Bayou d'Inde Group

Re: Bayou d'Inde Group Cooperative Agreement
AI No. 7443
Corrective Action Study Report

Combined Agency Comments and Bayou d'Inde Group Responses

Figure 3-13
Sediment Removal in AOL 2 (Option 2), Plan View
Corrective Action Study Report
Bayou d'Inde (Agency Interest 7443)

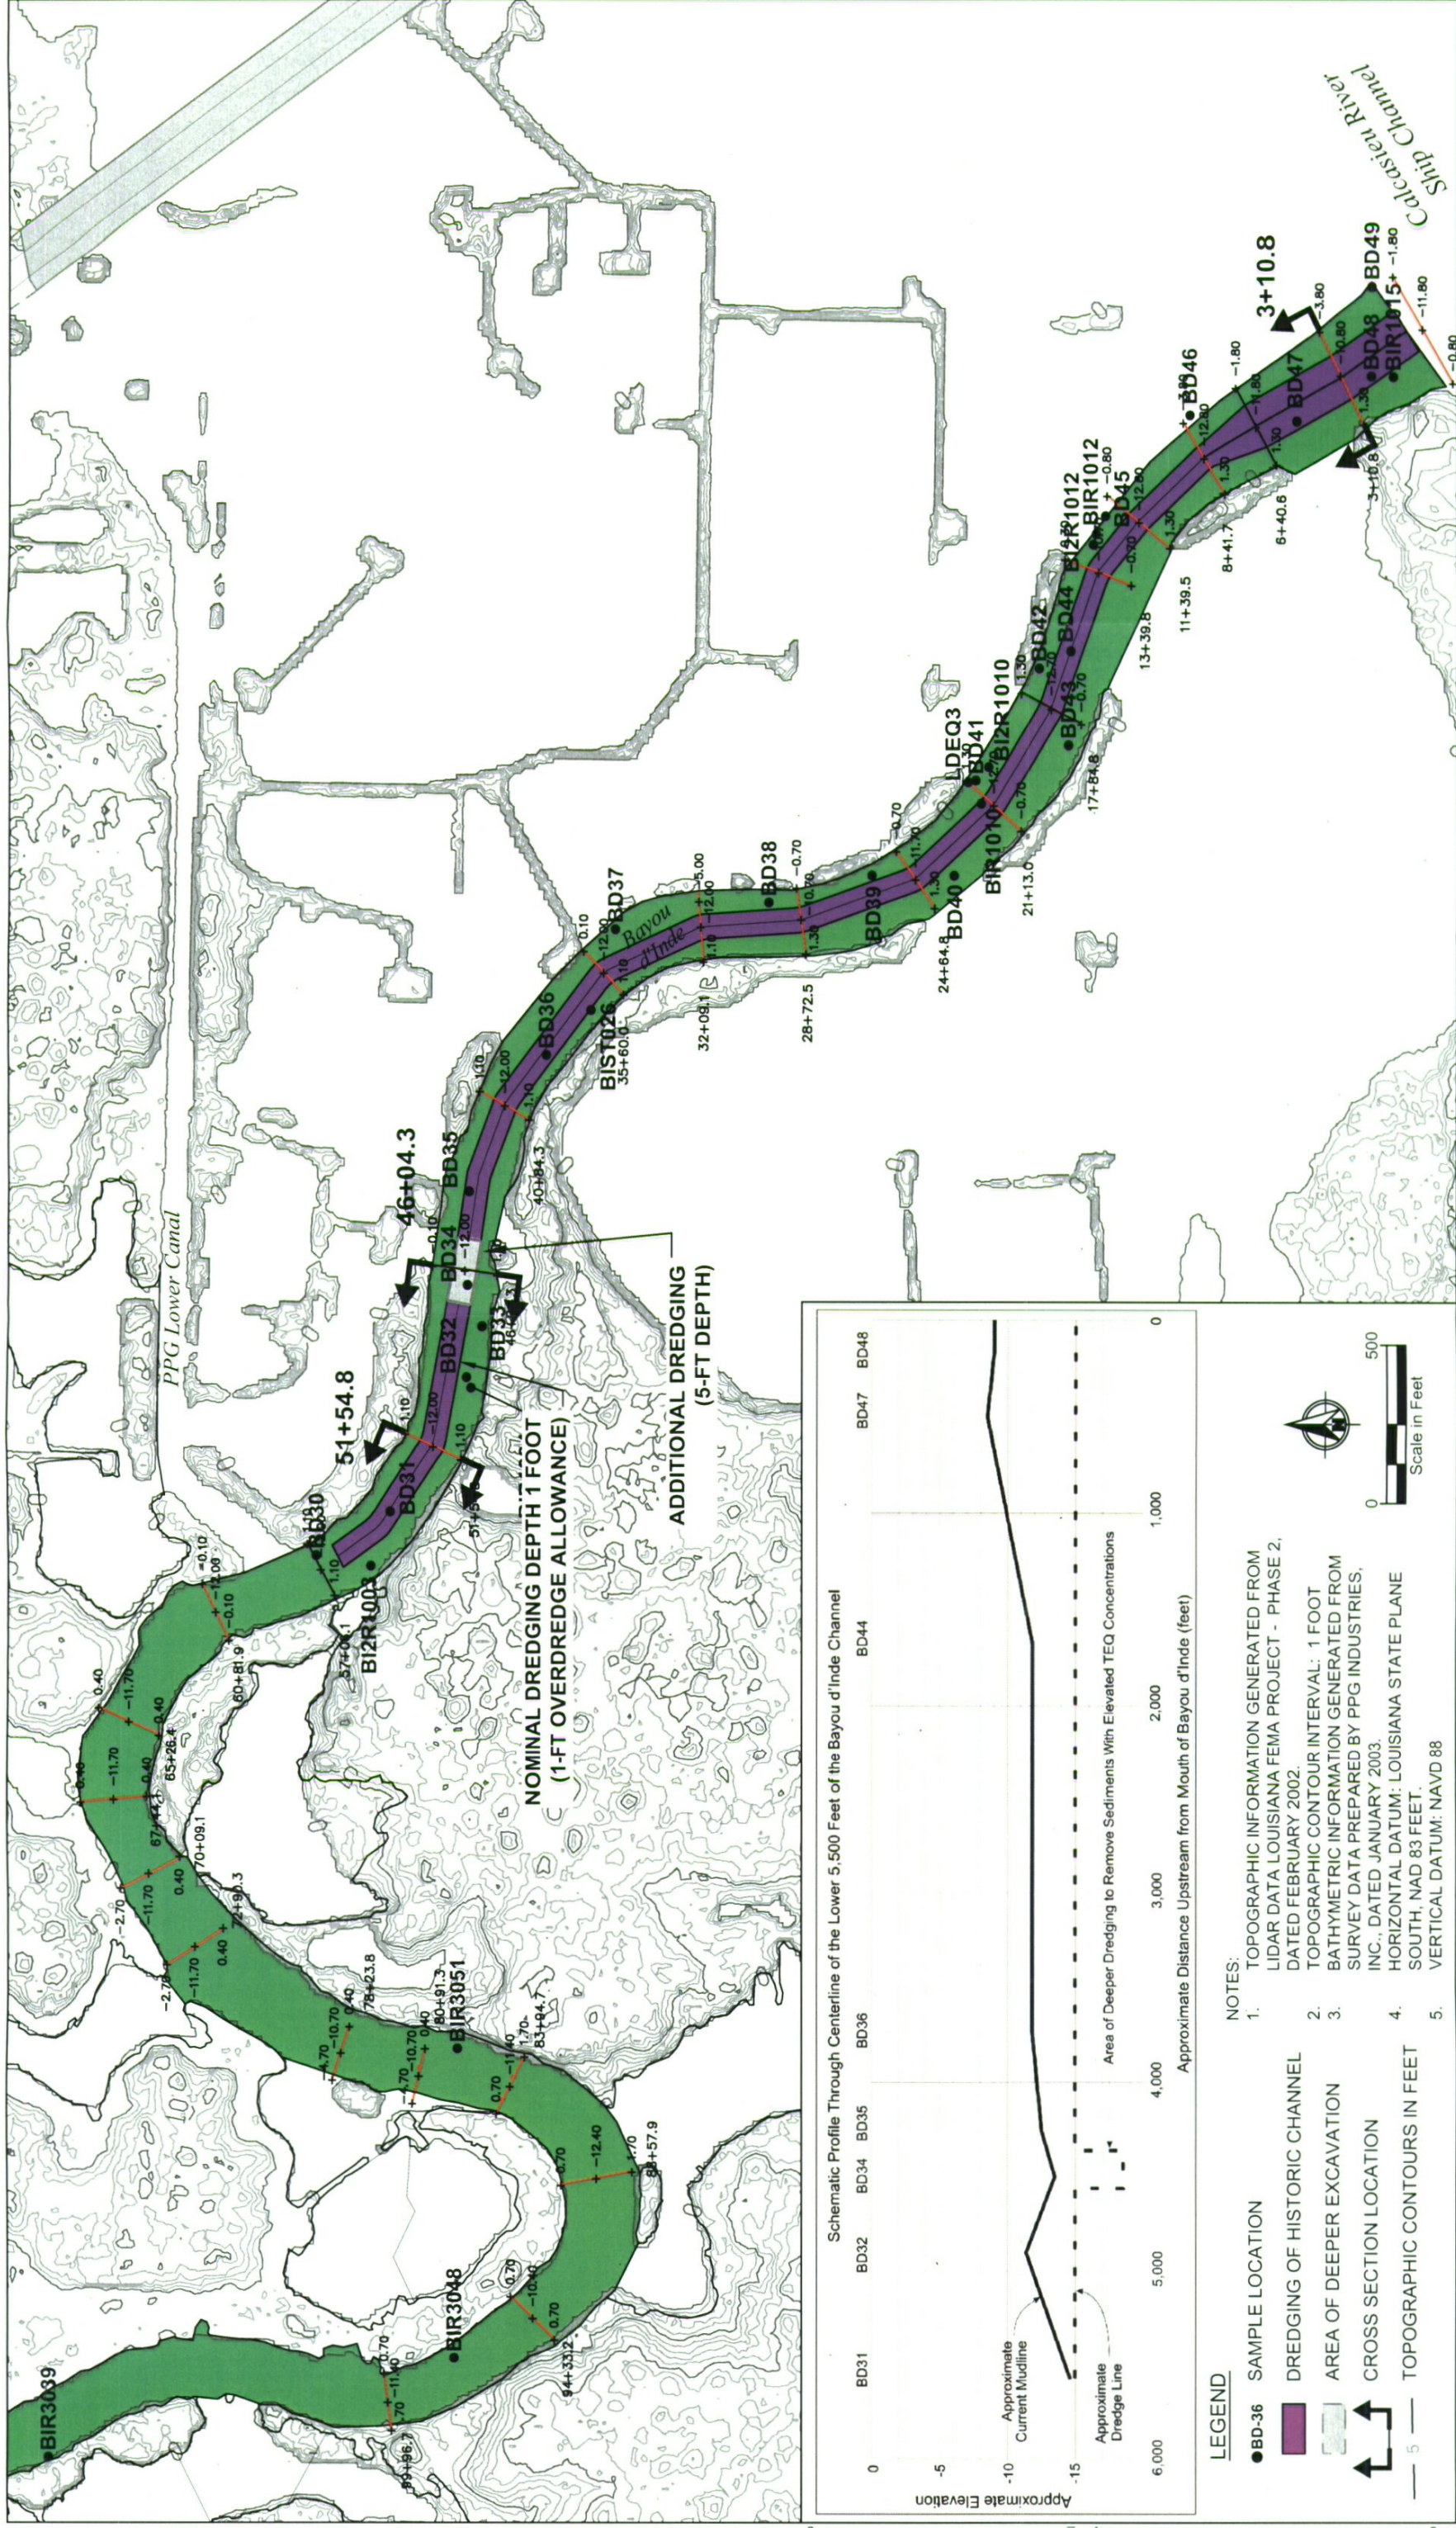
Comment 4. A description of the depths of dredging (i.e., number of feet of sediment removed) proposed for Area of Investigation (AOI) 2 (Option 2) should be provided in Figure 3-13.

Response: Figure 3-13 was modified to include several labels indicating target dredging depths for various areas in AOI 2. In addition, a profile indicating target dredging depths in the centerline of AOI 2 was added to Figure 3-13 for Removal

Option 2. For consistency, similar modifications were made to Figure 3-10 (for Removal Option 1).
